PREVOST

WARRANTY BULLETIN

WB18-07 A

DATE :	March 2018	SECTION :	06 ELECTRICAL
EXPIRATION:	March 2020		
SUBJECT :	REVERSED BUSBAR AT CIRCUIT BREAKER CB13 - VEHICLES EQUIPPED WITH A CURRENT INVERTER

FIGURE 3 : CORRECT INSTALLATION

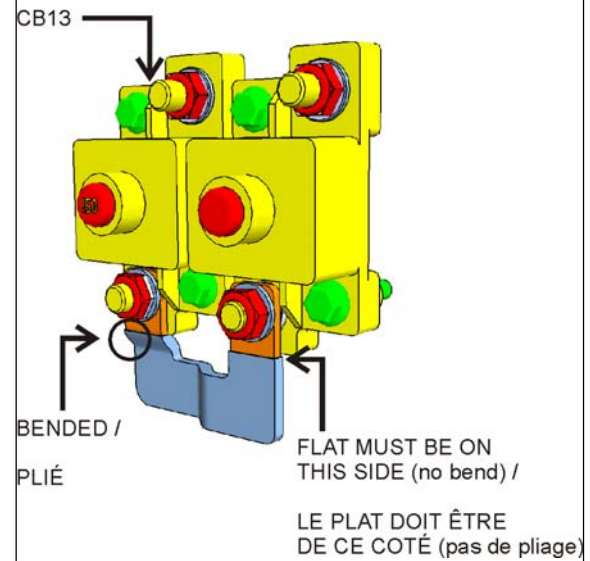
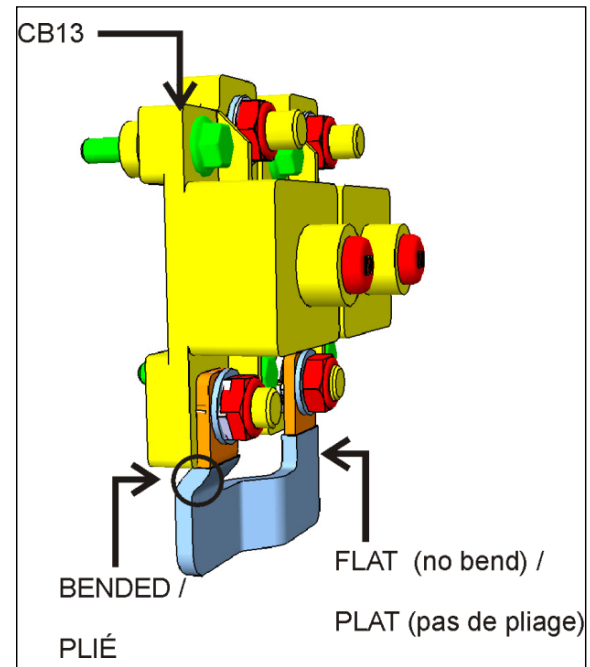
2. Check if the busbar is installed correctly. The “flat” on the busbar must be placed on the circuit breaker located on the R.H. side of CB13.
3. If the busbar is installed properly, no further verification is necessary, just connect the ground cable (see PART 4).

FIGURE 5: DISCONNECT THE GROUND CABLE WHERE INDICATED WITH A CIRCLE

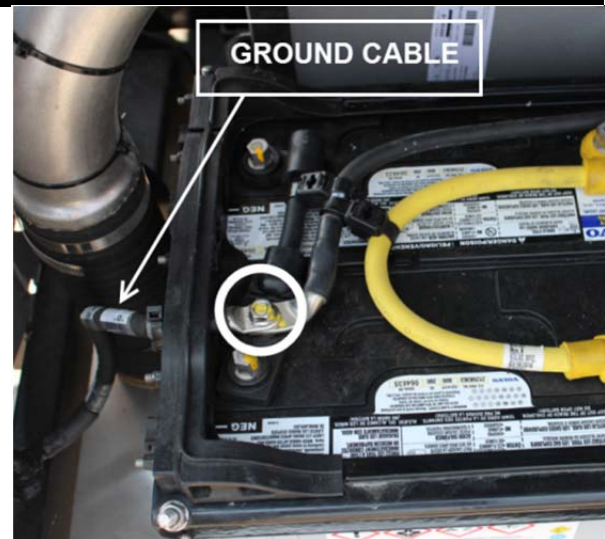
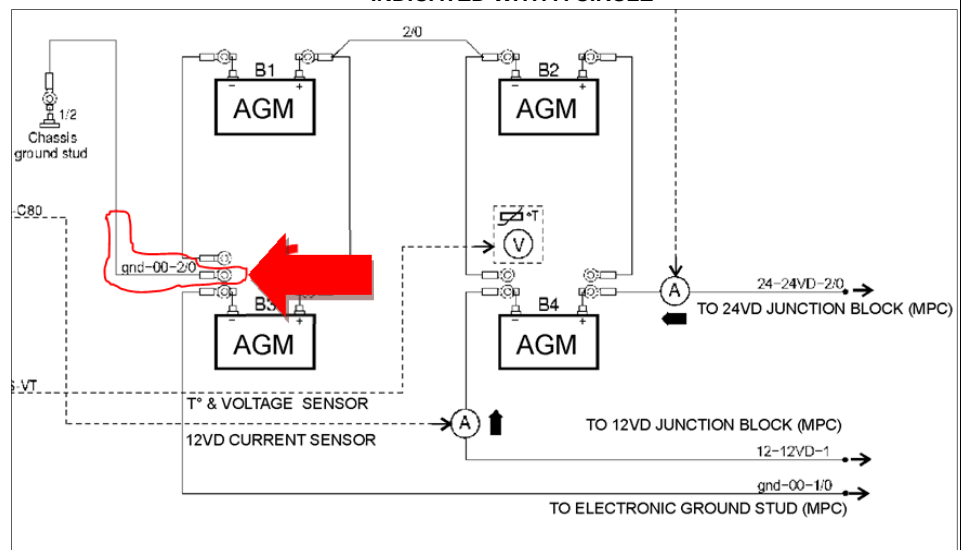
4. Breaker CB13 is connected directly to the battery. Therefore, it is necessary to disconnect the ground cable reaching to the chassis at the battery installation in order to avoid any risk of short circuit during the removal and installation of the busbar.

FIGURE 7

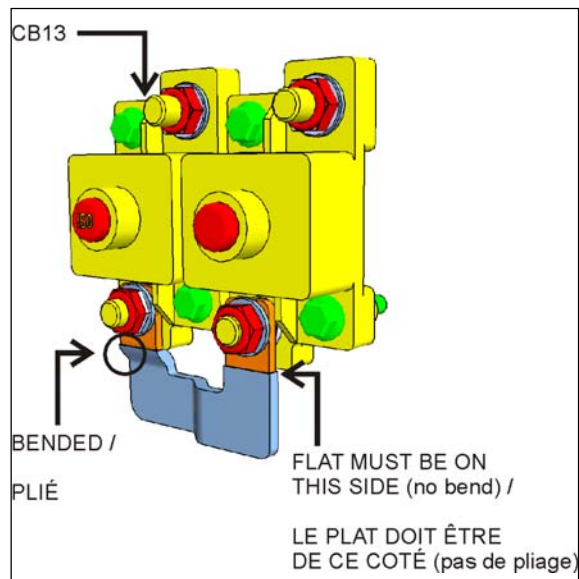
5. Remove the busbar and reinstall in accordance with the following criterion (see image at right) :

The “flat” on the busbar must be placed on the circuit breaker located at the R.H. side of CB13.

Nut torque: 135 lbs-in (15 Nm)

- a) Replace the busbar if it is damaged, warped or cannot assure a good electrical contact with the surface of the circuit breaker.

- b) Replace circuit breaker CB13 if the stud or the threads are damaged and cannot assure an adequate tightening/clamping of the busbar. This circuit breaker could be a 150A or a 90A depending on the equipment installed. **CAUTION: Replace with a circuit breaker of the same type/capacity.**

- c) Replace circuit breaker found at the right of CB13 if the stud or the threads are damaged and cannot assure an adequate tightening/clamping of the busbar. This circuit breaker could be a 150A or a 50A depending on the equipment installed. **CAUTION: Replace with a circuit breaker of the same type/capacity.**

FIGURE 8

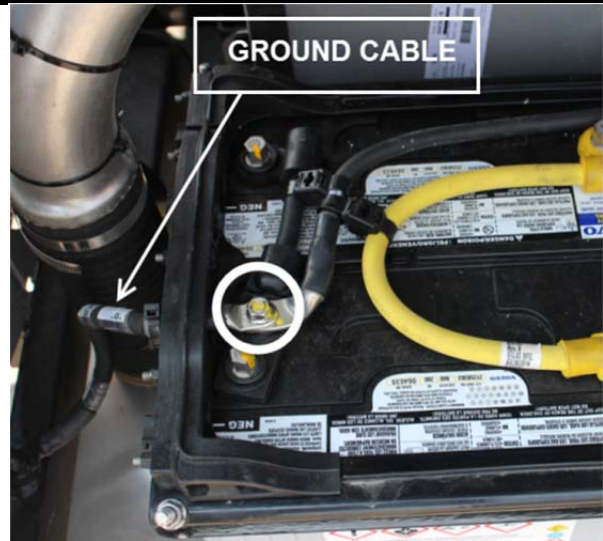
6. Connect the ground cable.

Nut torque: **170 lbs-in (19 Nm)**
